Info Only: Comments from Service Engineering and Stormwater Engineering are in blue text.

Flying Horse North Filing No. 5 Final Drainage Report

October 2024

PCD File No. SF____ SF2427

FLYING HORSE NORTH SKETCH PLAN

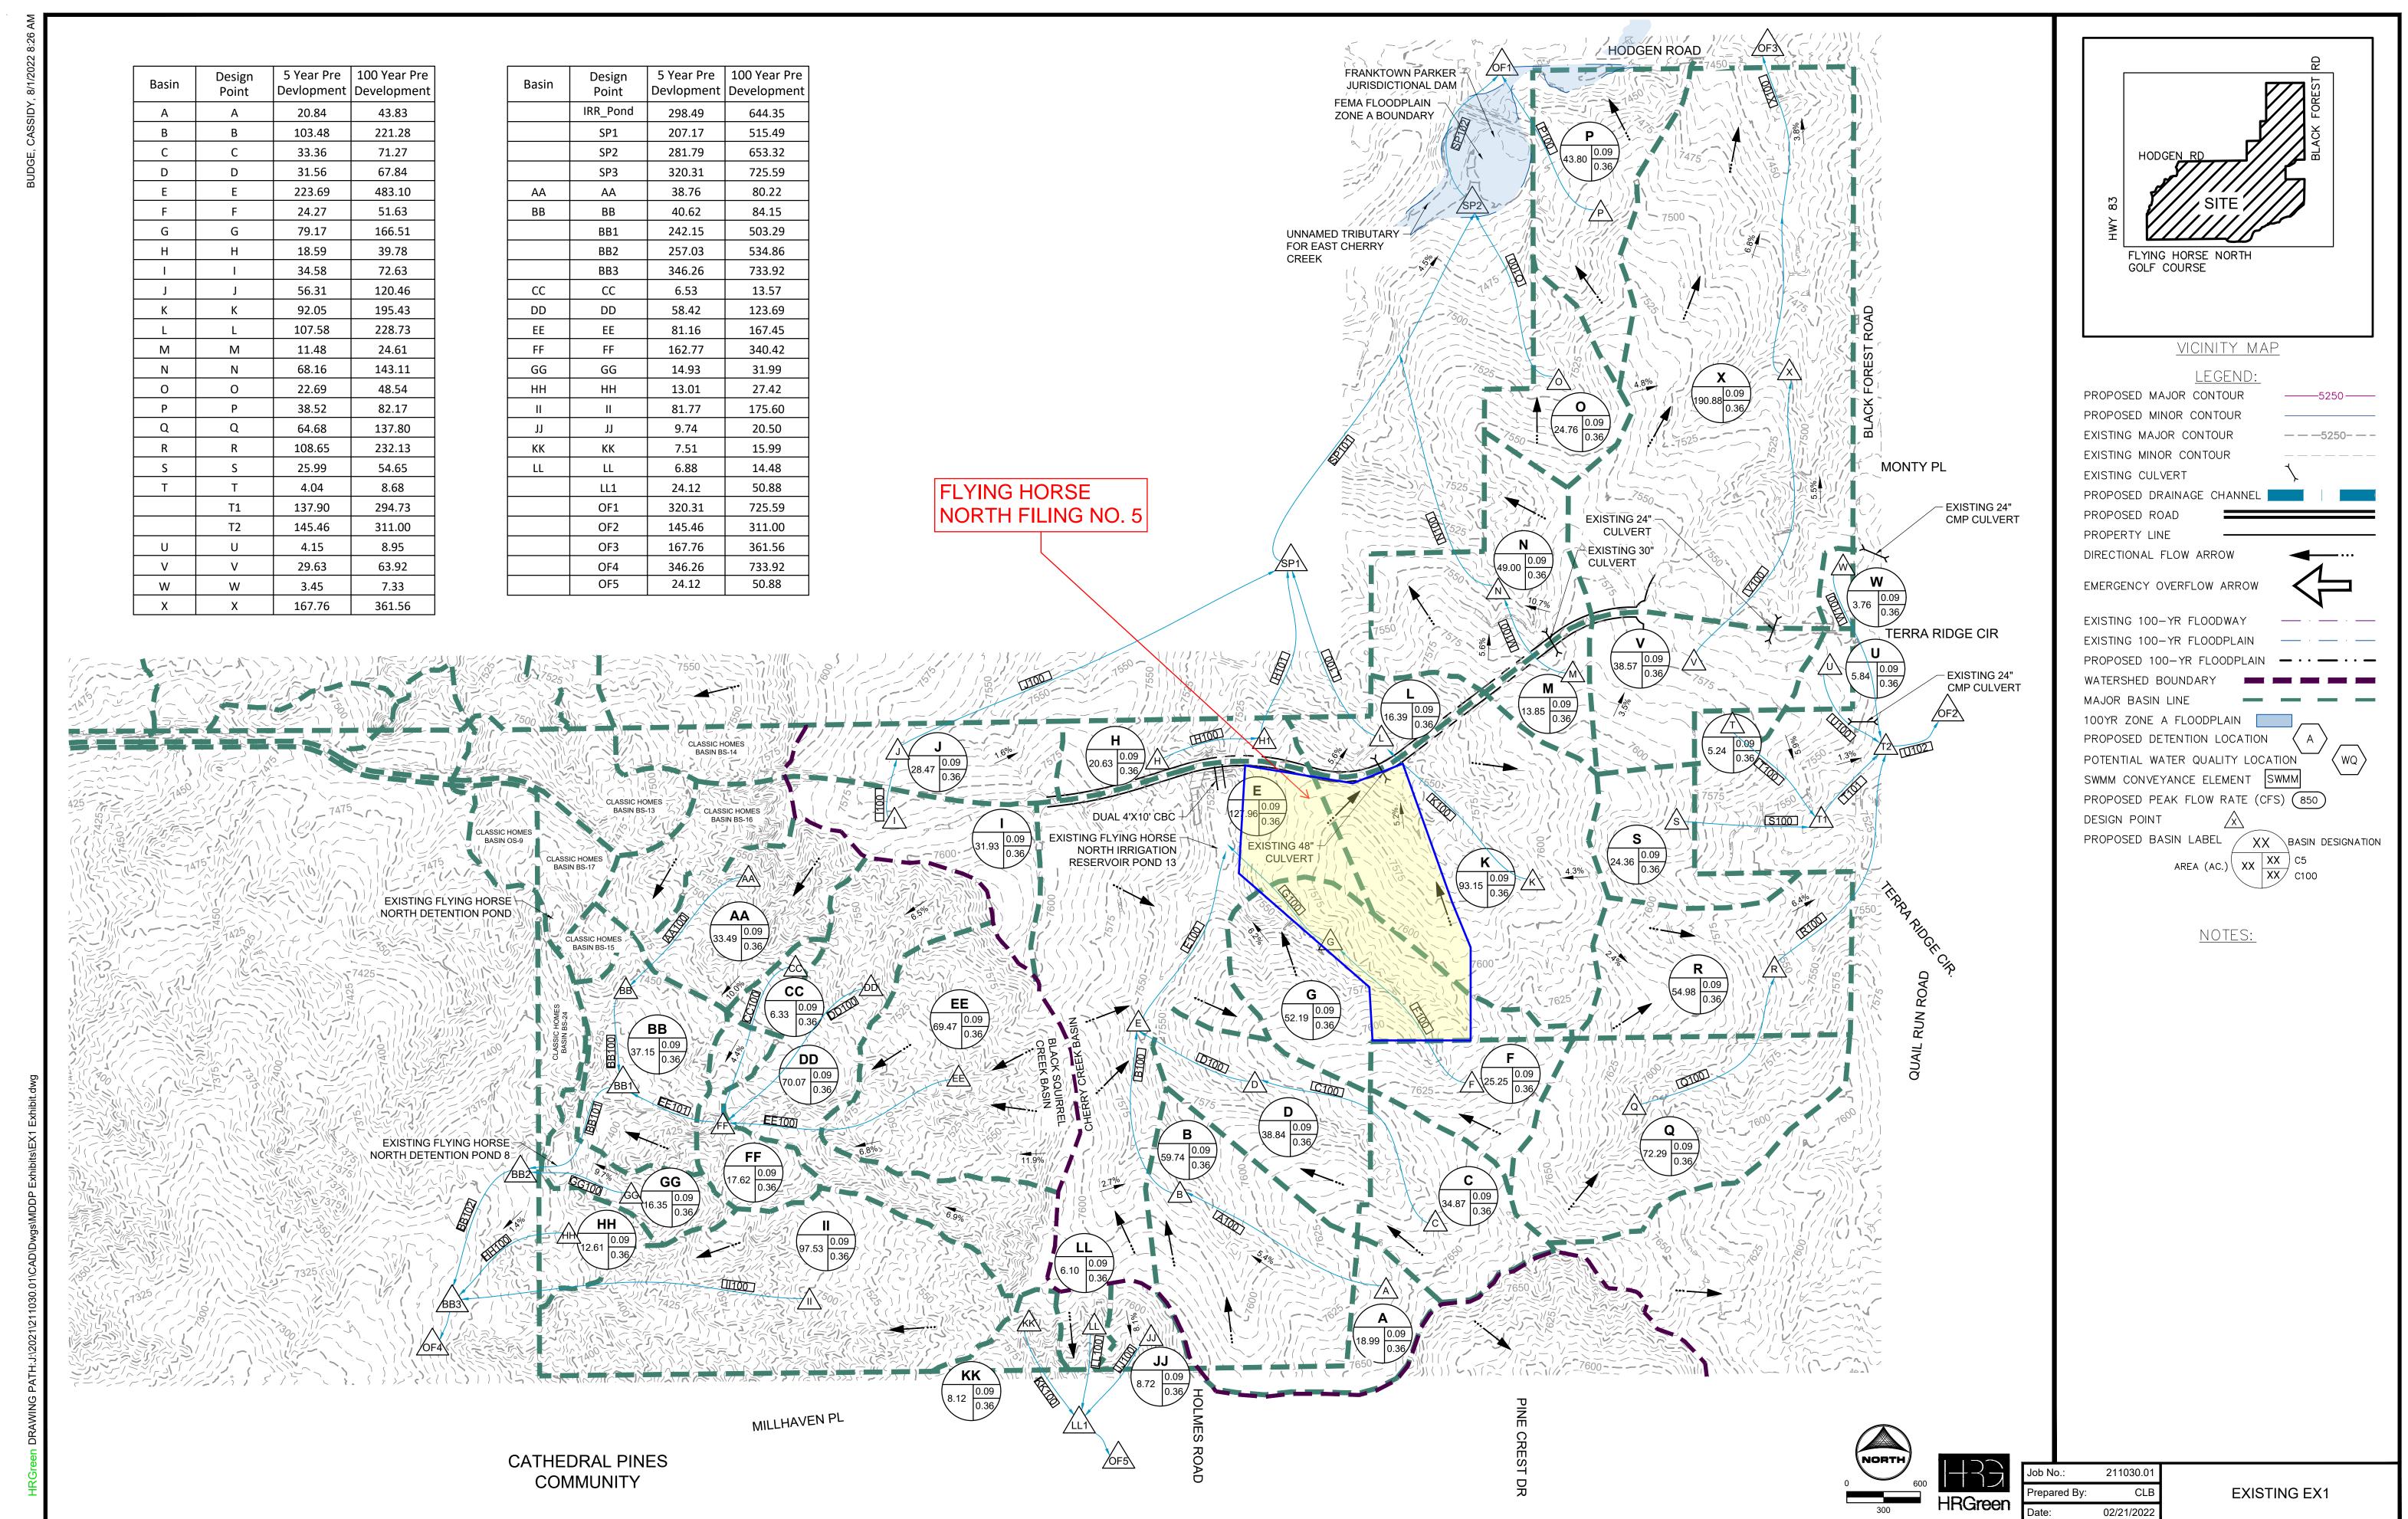
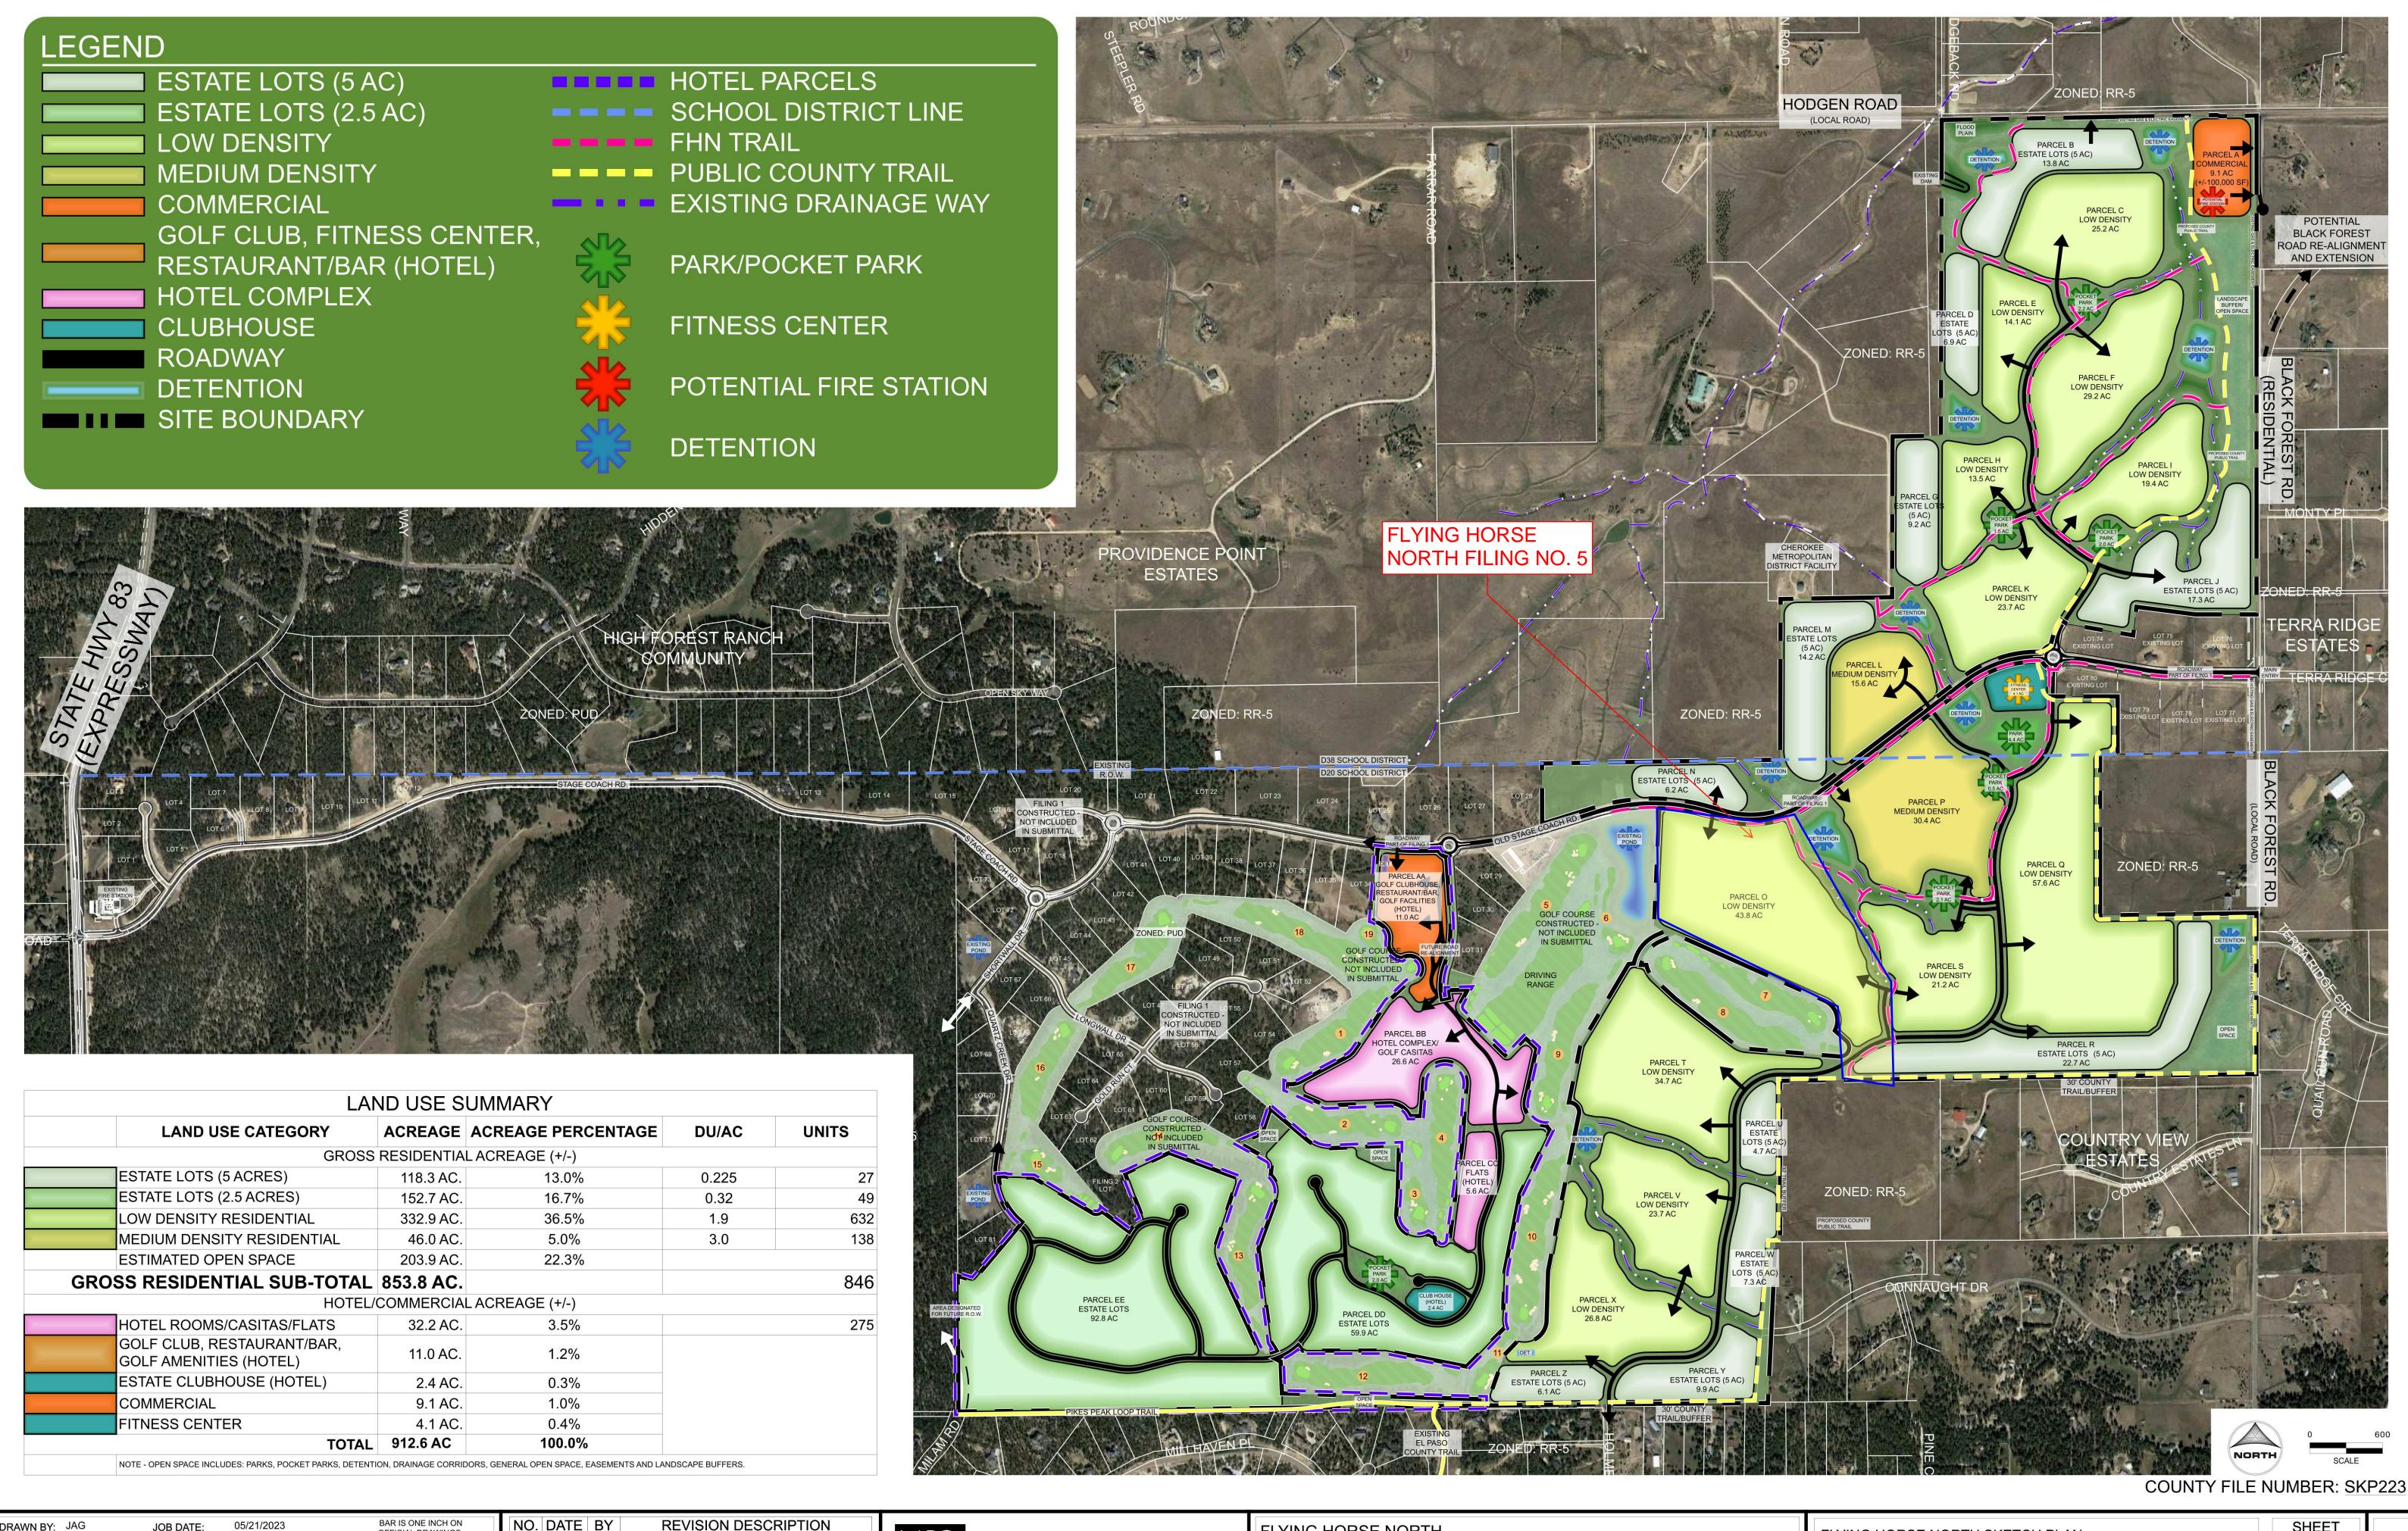
Why is Pond 8 circled? Pond B and the Irrigation reservoir are discussed as providing treatment, if Pond 8 is also providing treatment discuss above or clarify with some additional text why this section is boxed.

See comment above, why are the Pond 8 calcs provided? Clarify with some text.
